Title: Design and Installation of a Microgrid at the High Commission of Canada in South Africa, in Pretoria

Solicitation Number: 24-250214

Questions & Answers # 3

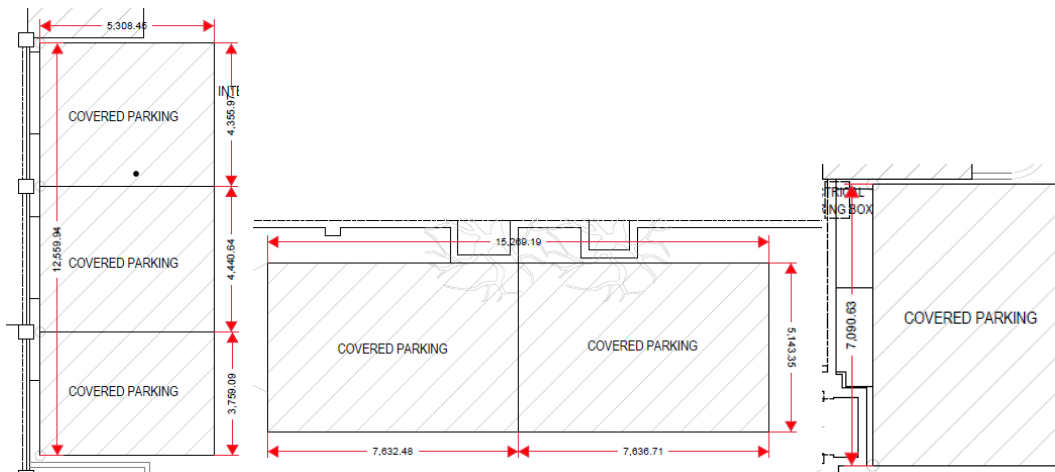
Q22. “Please confirm whether tree-cutting or trimming will be allowed.”

A22. *Tree cutting/trimming within the compound of the High Commission would be allowed to some extent if the benefits outweighs the drawbacks and as long as it is approved by Municipality.*
